Transmission Expansion Advisory Committee

Generation Deactivation Notification Update

August 13, 2015

Revised B2019 Project Scope Contd..

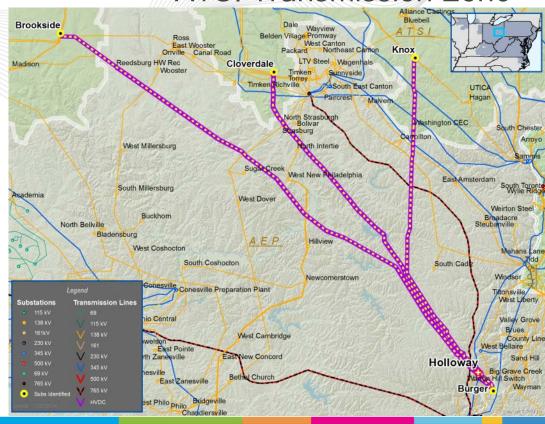
- New Baseline Remove both Burger 138 kV substations (East and West 138 kV buses) and all 138 kV lines on the property (B2019.4)
- Estimated Project Cost: \$2.15 M
- Required IS Date: 6/1/2016
- ATSI (the local TO) will be the designated entity
- New Baseline Terminate and de-energize the 138 kV lines on the last structure before the Burger Plant property (B2019.5)
- Estimated Project Cost: \$0.85 M
- Required IS Date: 6/1/2016
- ATSI (the local TO) will be the designated entity
